PCN#20220802000.1
Qualification of new Fab site (FFAB) using qualified Process Technology, Die Revision, and additional Assembly, Datasheet & BOM option for select devices

Change Notification / Sample Request

PCN Number:	20220802000.1	**PCN Date:**	August 03, 2022
Title:	Qualification of new Fab site (FFAB) using qualified Process Technology, Die Revision, and additional Assembly, Datasheet & BOM options for select devices		
Customer Contact:	PCN Manager	**Dept:**	Quality Services
Proposed 1st Ship Date:	Oct 31, 2022	**Sample Requests accepted until:**	Sept 3, 2022*

Sample product shipping label (not actual product label)

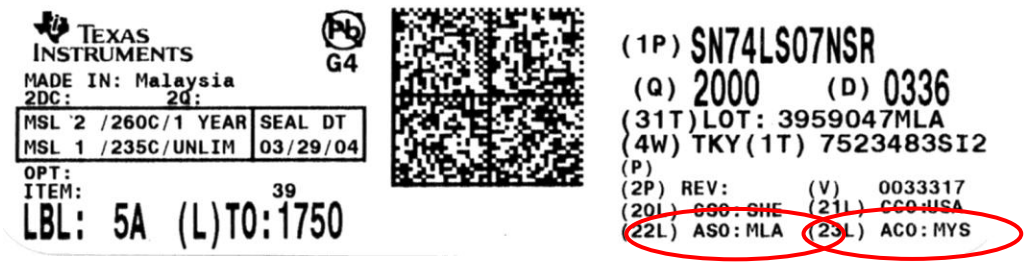
Changes to product identification resulting from this PCN:

Fab Site Information:

Chip Site	Chip Site Origin Code (20L)	Chip Site Country Code (21L)	Chip Site City
SH-BIP-1	SHE	USA	Sherman
FFAB	**FRE**	**DEU**	**Freising**

Die Rev:

Current	**New**
Die Rev [2P]	**Die Rev [2P]**
E	**A**
